Report: TAB Remarks
Function: Test, Adjust, & Balance
Date: 03/31/2026
Completed By: National TAB

Moxies Restaurant (Fort Lauderdale, FL)

Project: Moxies Restaurant (Fort Lauderdale, FL)

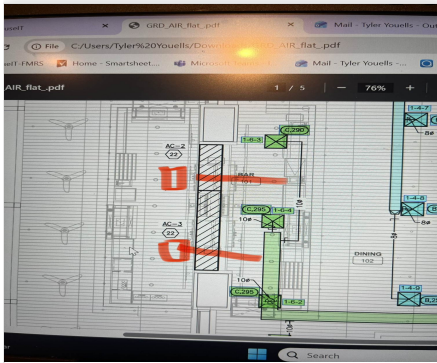
Issue Name : Additional AHU 1-6 Diffusers install
Description : Diffusers in the lower level exterior facing bar area are not fully connected to the ductwork and is causing drafting above the ceiling. Air is not properly being distributed into the space. Recommend MC properly connect collar to diffuser face for both diffusers in this area
Created By : National TAB **Assigned To :** National TAB - Joe Hertenstein
Status : Open
Priority : Urgent **Asset Tag :**
Originated Date : 03/31/2026 - Tyler Youells - National TAB

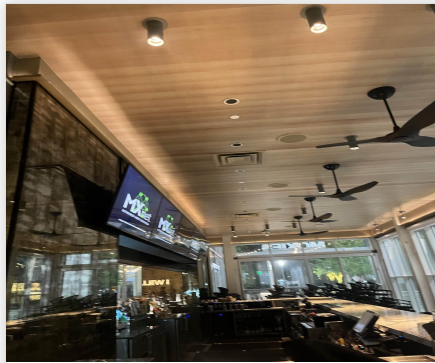
Issue Name : AHU 1-6 Ducting
Description : Two diffusers installed in the lower level exterior facing bar not shown on drawings, they appear to be connected to AHU 1-6 but need a taller ladder to confirm.
Created By : National TAB **Assigned To :** National TAB - Joe Hertenstein
Status : Open
Priority : InfoOnly **Asset Tag :**
Originated Date : 03/31/2026 - Tyler Youells - National TAB

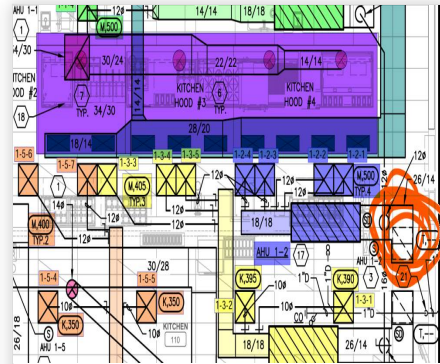
Issue Name : AHUs Note CW
Description : Note that these units are not AHUs they are water source heat pumps they are not provided with chilled or Hot water they are provided with condenser water. Note that the water piping to units does not have any balance valve for flow to be measured by TAB technician.
Created By : National TAB **Assigned To :** National TAB - Tyler Youells
Status : Open
Priority : InfoOnly **Asset Tag :**
Originated Date : 03/31/2026 - Tyler Youells - National TAB

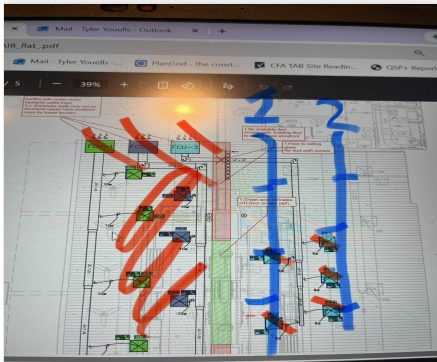
Issue Name : Air filters need to be changed
Description : air filters are well pass the change date.
Created By : National TAB **Assigned To :** National TAB - Joe Hertenstein
Status : Open
Priority : Medium **Asset Tag :**
Originated Date : 03/31/2026 - LAURA CUESTA - National TAB

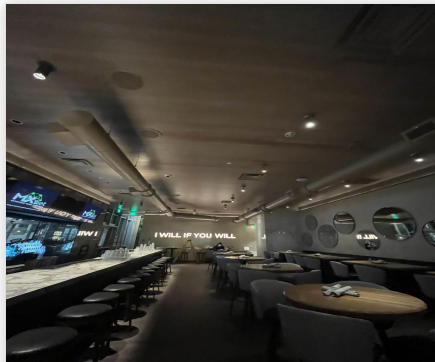
Issue Name : FCUs Note
Description : FCUs 1/2 are located, FCUs 3/4 are not found. Ducting does not match the prints and duct is exposed spiral and not connected to 4 way diffusers. Need to figure out if FCUs 3/4 exist.
Created By : National TAB **Assigned To :** National TAB - Tyler Youells
Status : Open
Priority : InfoOnly **Asset Tag :**
Originated Date : 03/31/2026 - Tyler Youells - National TAB
